Bulletin No.:	9573L30-01
Corp. Rel. No.:	57-71-09
Date:	April, 1995

Product Service Bulletin

SUBJECT: TORQUE CONVERTER CLUTCH (TCC) CHUGGLE/HUNTING CONDITION

MODELS: 1989-1995 GEO TRACKER, CAMI VITARA, SUZUKI SIDEKICK
WITH HYDRA-MATIC 3L30 AUTOMATIC TRANSMISSION

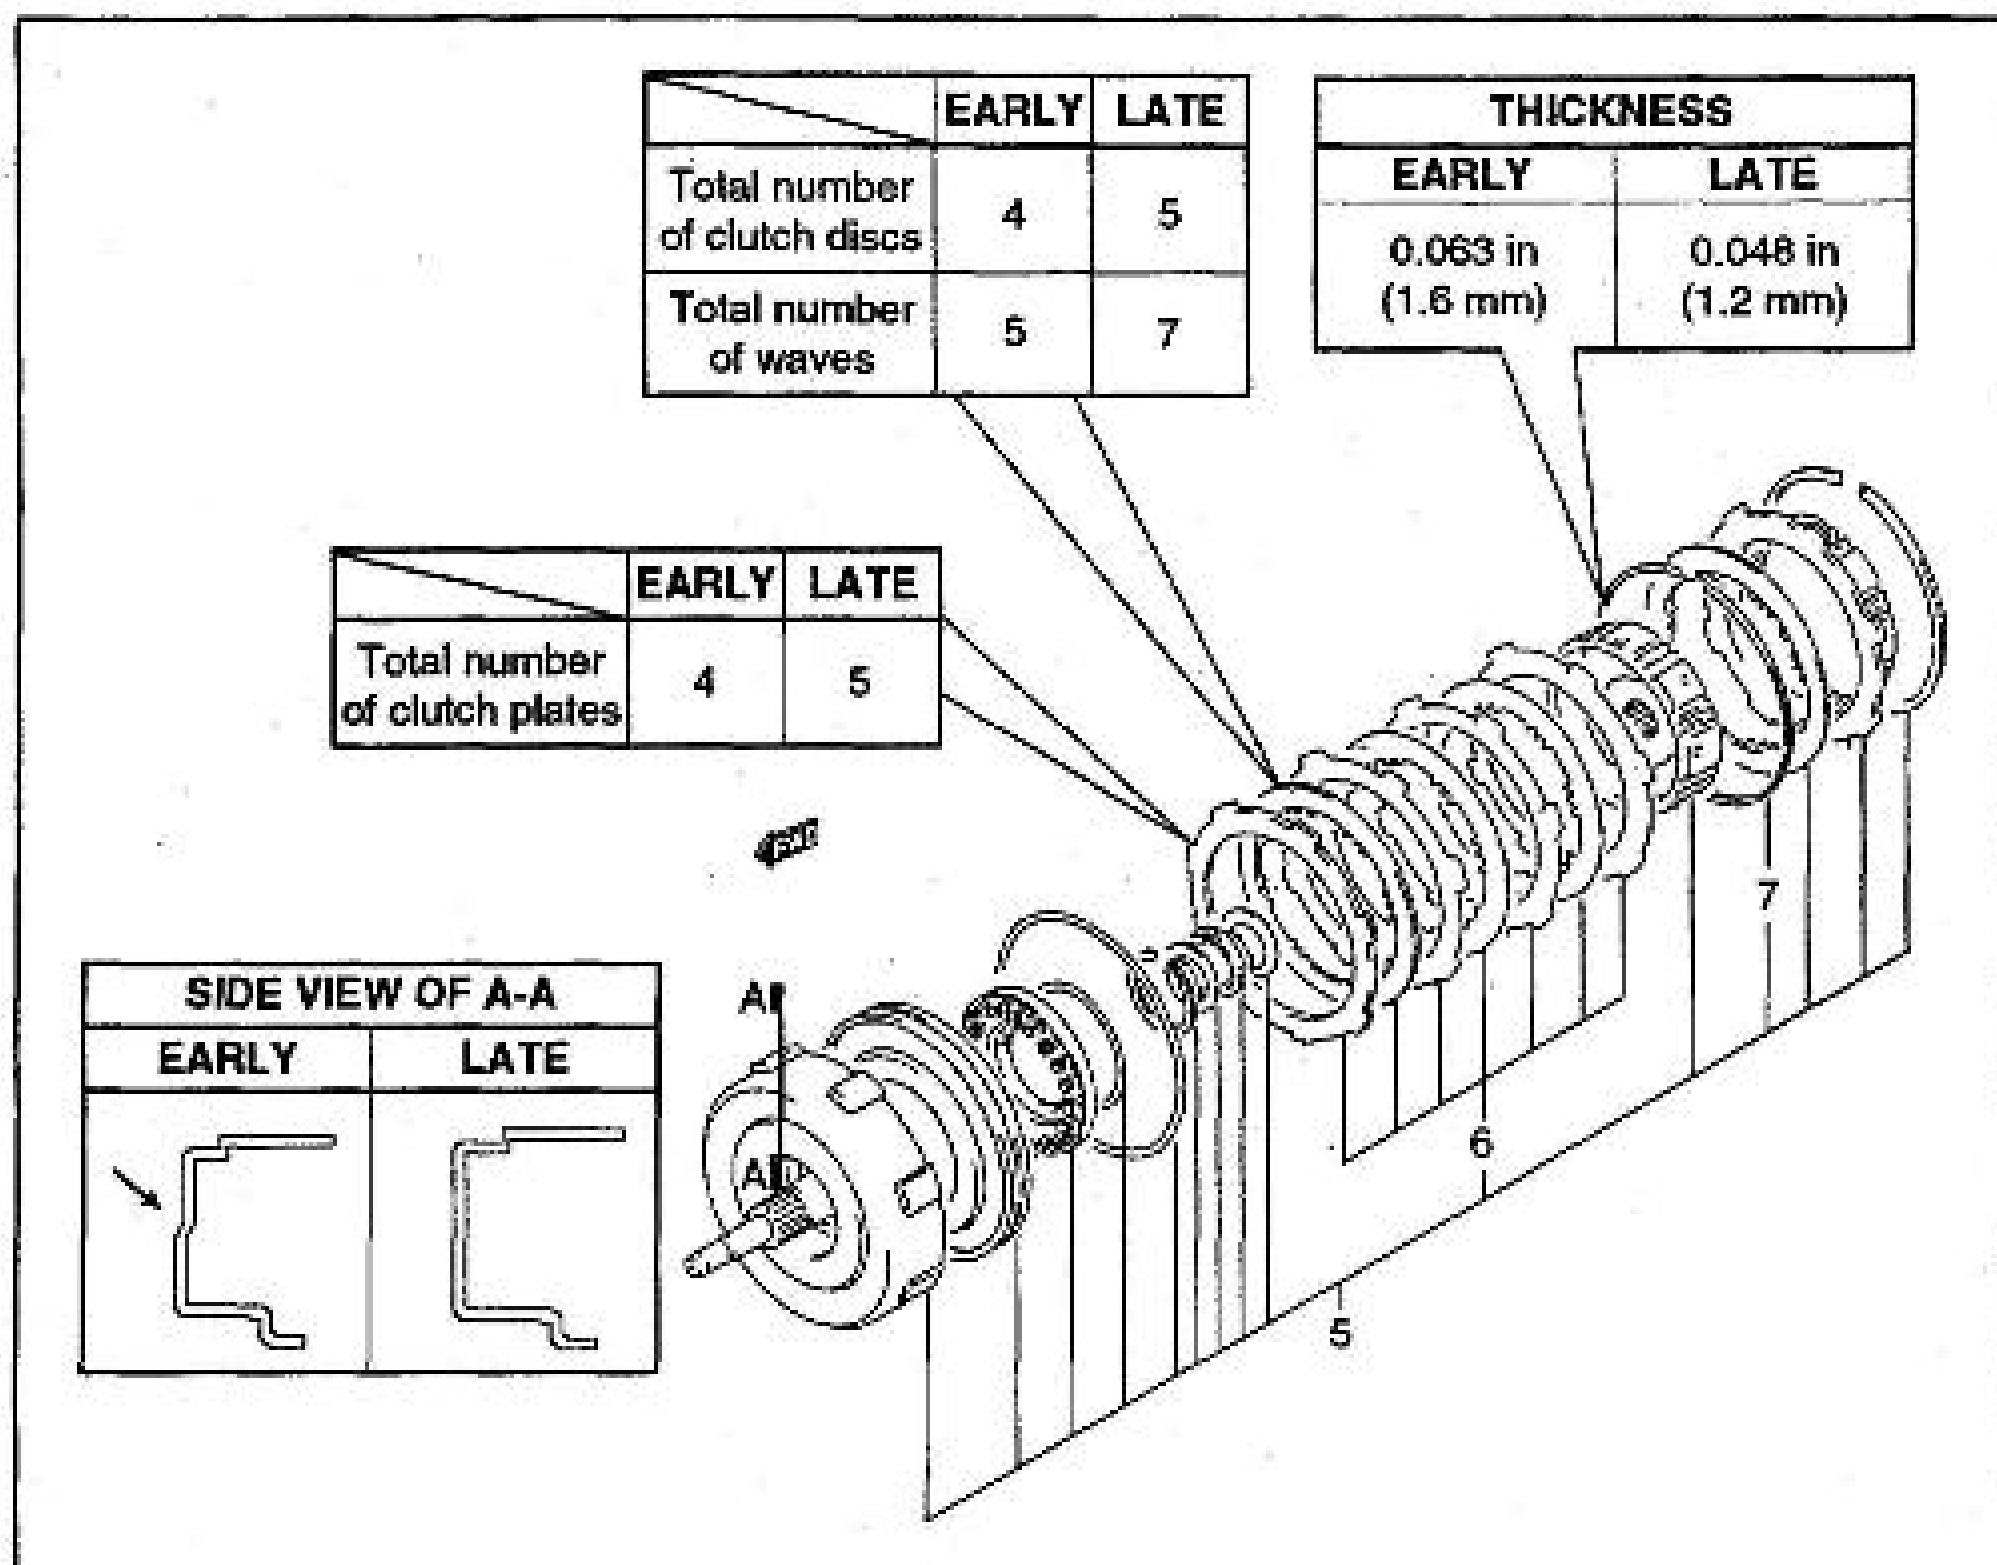
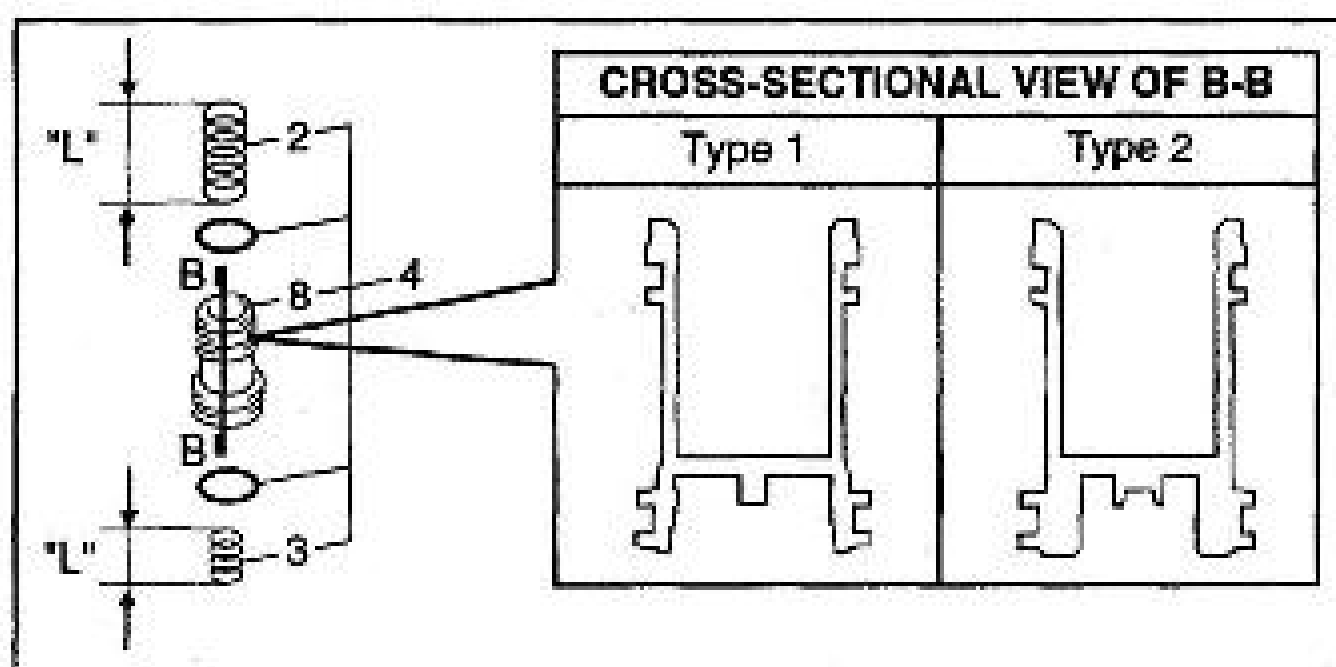
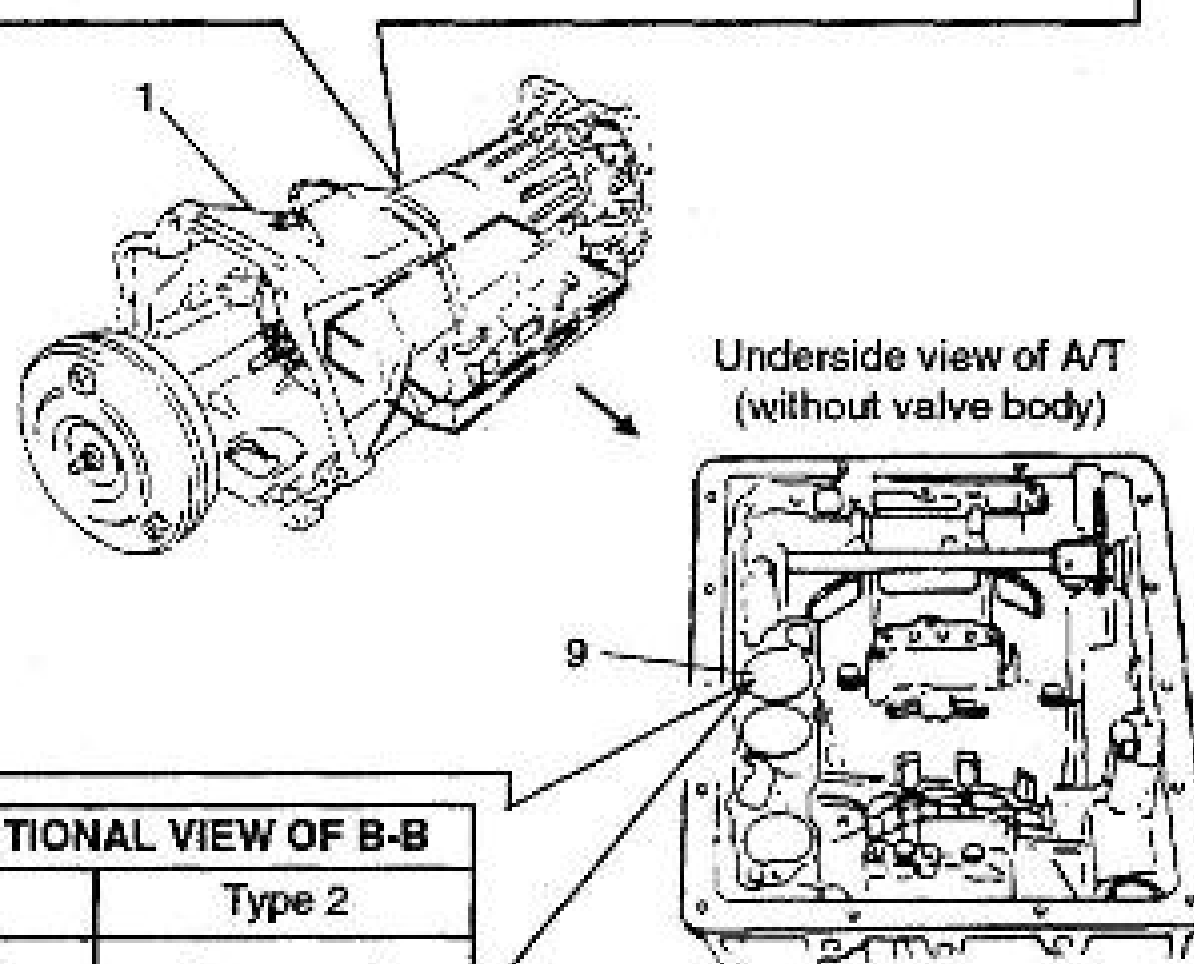
CONDITION: Excessive gear shift shock.

This bulletin is to inform you of the modification of the inner parts for the 4-Speed Automatic Transmission which has been carried out since January 1997 production. The modifications listed in this bulletin were introduced to reduce gear shift shock when shifting from Neutral to Drive, Neutral to Reverse, and First to Second gears. When rebuilding the transmission, please use the parts as listed in this bulletin.

CORRECTION: Install updated parts as listed in this bulletin.
